**CITY OF KELOWNA**  
**MEMORANDUM**

**APPLICATION NO.:** OCP04-0021/Z04-0078

**PURPOSE:** To amend the Official Community Plan Future Land Use designation from Single/Two Unit Residential to Multiple Unit Residential – Medium Density and to rezone from the A1-Agriculture 1 zone to the RM4 – Transitional Low Density Housing zone in order to facilitate a transitional low density multi family residential development

**AT:** 492 Clifton Road

## **3.1 The Proposal**

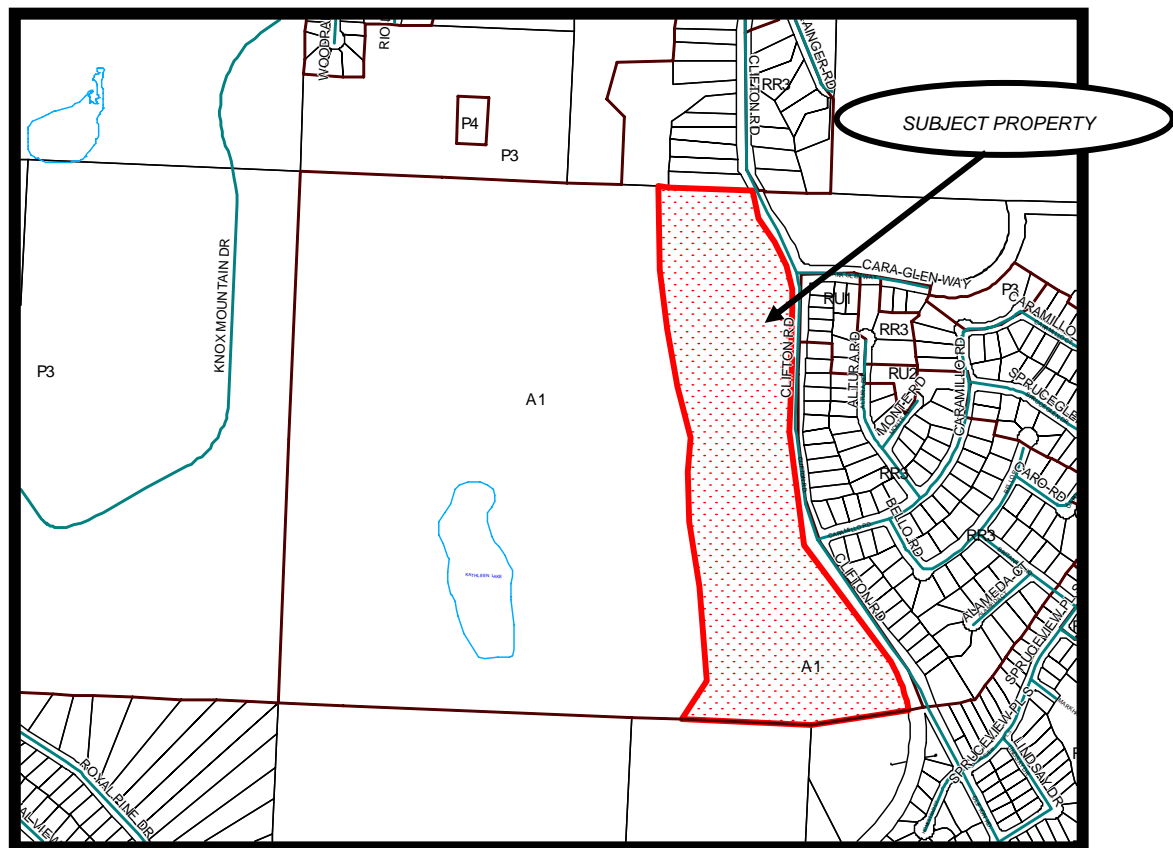
- a) The internal road Layout should be confirmed. Adjacent lands to the south have proposed different access points for the internal roads. Provide a pre-plan with all the adjacent lands, to confirm intersection and road alignments

- a) Provide a drainage pre-design and preliminary storm water management plan.
- b) The concept plan shows multiple cascading ponds; the drainage Division is not supportive of this concept for detention facilities because of the multiple controls and additional maintenance effort. Proposed detention systems are subject to approval of the Drainage Engineer. Input from the Environmental Division and Parks Department may also be required. The concept should be dealt with prior to rezoning.
